SITE PLANS & GENERAL NOTES
FOR GUARDRAIL CONNECTION
AT VARIOUS STRUCTURES

FARRINGTON HIGHWAY RESURFACING
Ulehana Stream Towards Pili-o-koe Bridge
F.A. Proj. No. F-093-1(7)

TYPICAL DETAILS
GUARD RAIL CONNECTION
TO EXIST. END POST
FARRINGTON HWY RESURFACING
ULEHAWA STREAM TOWARDS PILIOKOE BRIDGE
F.A. Proj. No. F-023-1(2)
Scale: As Noted Date:

SECTION B
Scale: 3/4" = 1'-0"

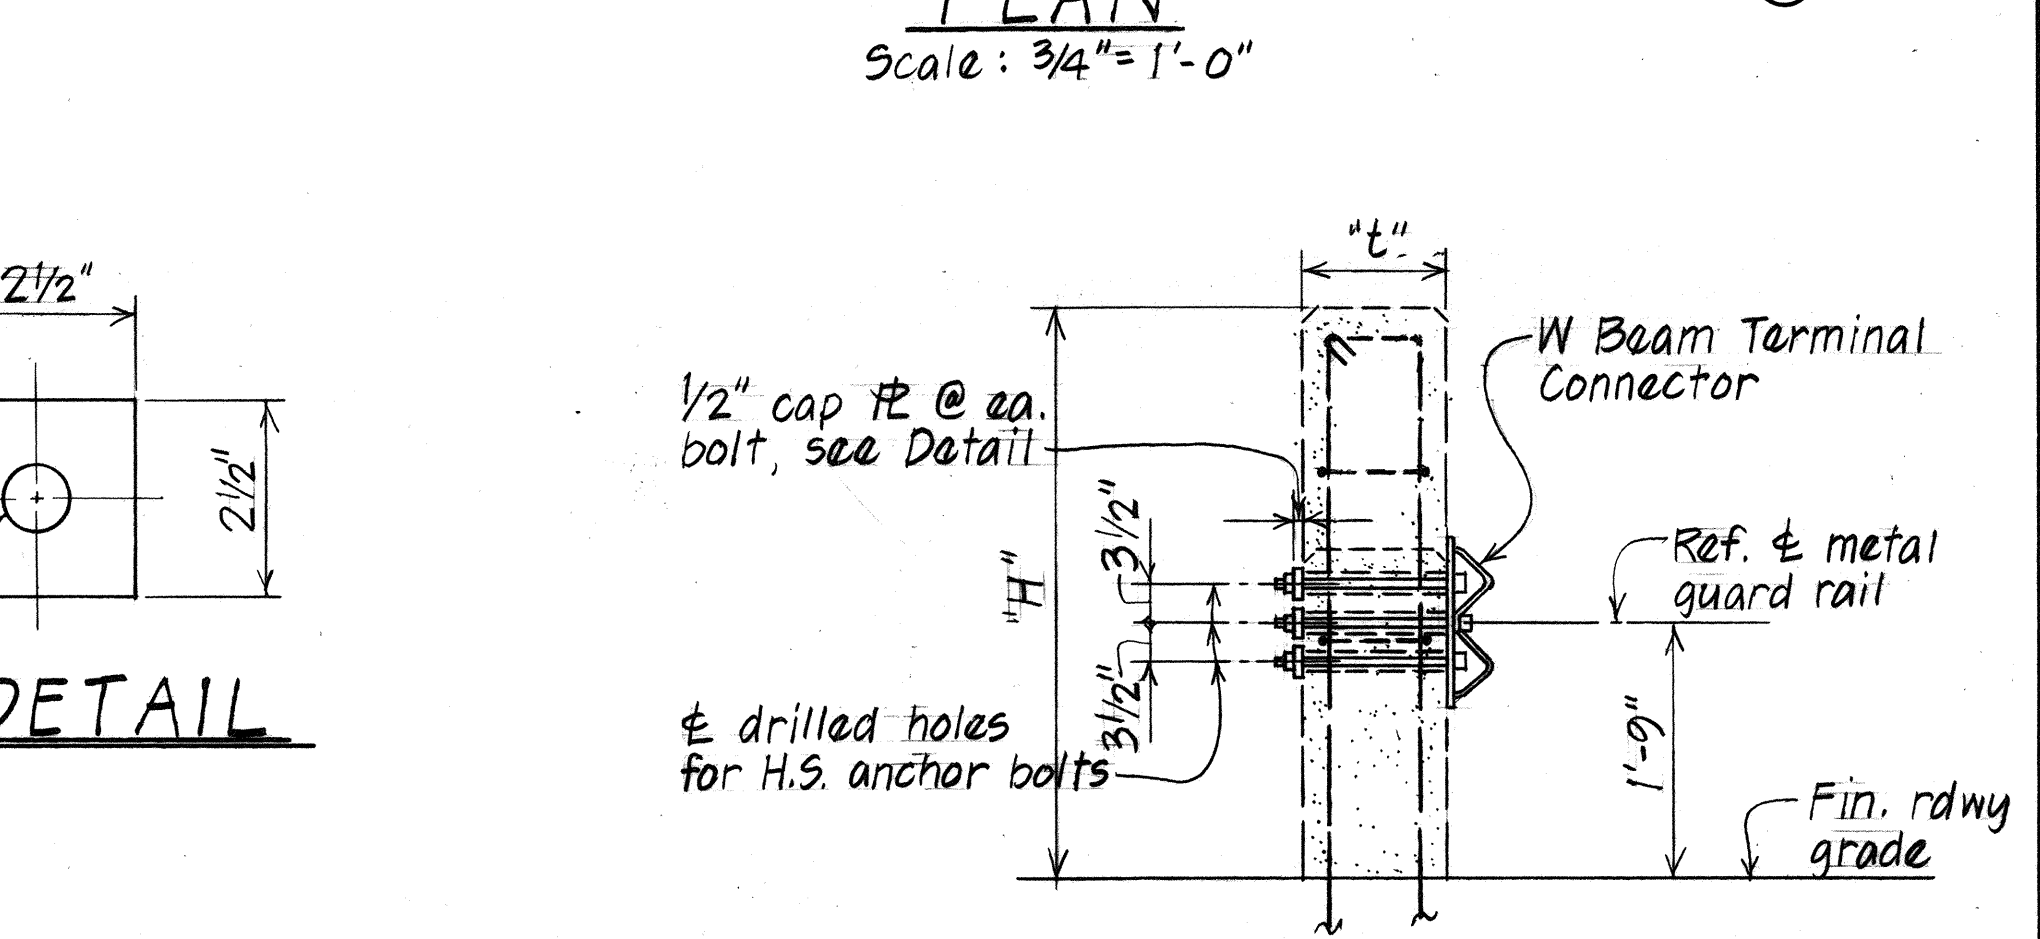
The words "Mauka" and "Makai" deleted from EXISTING END POST DIMENSION SCHEDULE per Addendum No. 1.
